XVIII Congreso EXPORAIL 2019

AAR Interchange Rules Revisions Update For 2019

FIGURE A

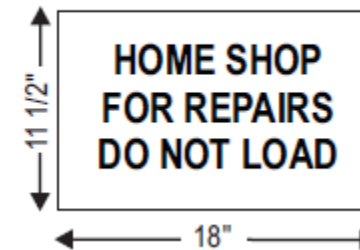
- 6- **5.** Home Shop **Marking**

- a. When applied, Home Shop **Markings shall be** at least 2 inch letters **reading** “HOME SHOP FOR REPAIRS DO NOT LOAD” and **shall contrast with the car body.**

- b. When applied Home Shop Decal shall be as shown in Figure **A** below and shall utilize black letters and black border on green-yellow background.

- c. When a car is sent to home shop, Home Shop **Marking** or Decal shall be applied to each side of car adjacent to car number.
